DEPARTMENT OF TRANSPORTATION**National Highway Traffic Safety Administration****49 CFR Part 572****[Docket No. NHTSA-01-11111]****RIN 2127-AH02****Anthropomorphic Test Devices; 3-Year-Old Child Crash Test Dummy**

ACTION: Final rule; response to petitions for reconsideration.

Figure P4

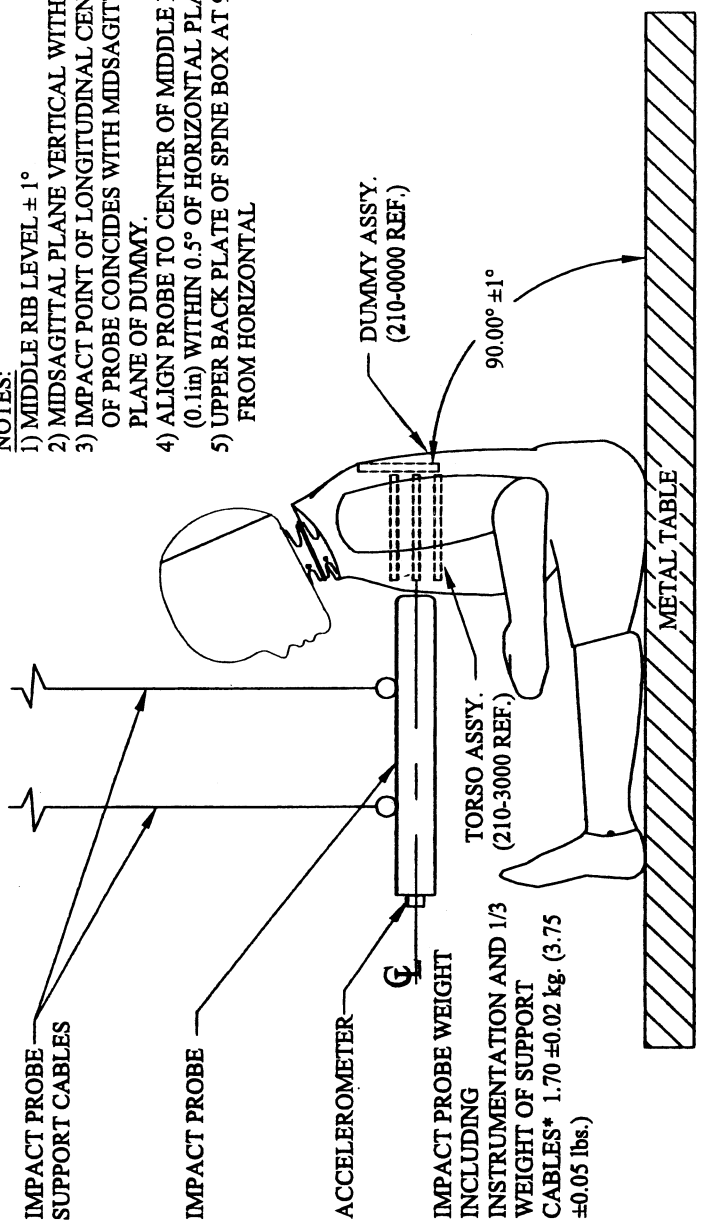
Mass (Weight) Distribution: Section 572.146(a) also specified that the test probe shall have a mass of $1.70 \pm .01$ [kilograms] kg (3.75 ± 0.02 (pounds)(lb)). The Alliance and FTSS believed that a weight tolerance of 10 grams is too small to be practically measured. The Alliance requested that the tolerance be increased to ± 0.02 kg (± 0.05 lb). FTSS recommended ± 0.023 kg.

NHTSA's Response: NHTSA agrees that the tolerance of ± 0.02 lb might be difficult to achieve because some of the accelerometers used on the crash test equipment weigh as much as 0.02 lb while others are as low as 0.002 lb. The agency believes that the total impactor weight tolerance should, to the extent possible, take into account the weight differences between many possible types of accelerometers used on impactors. Accordingly, we agree with the Alliance recommendation to increase the overall weight tolerance to ± 0.02 kg (± 0.05 lb), which allows less than 3 percent variation in the overall weight of the impactor. The weight specification is also changed in Figure P4 of Part 572, Subpart P, titled "Thorax Impact Test Set-Up Specifications."

4. In § 572.146, revise paragraph (a), add paragraph (l)(2)(iv), and revise Figure P4 to read as follows:

* 1/3 WEIGHT OF PROBE SUPPORT CABLES AND THEIR ATTACHMENTS TO THE IMPACT PROBE NOT TO EXCEED 5% OF THE TOTAL IMPACT PROBE WEIGHT.
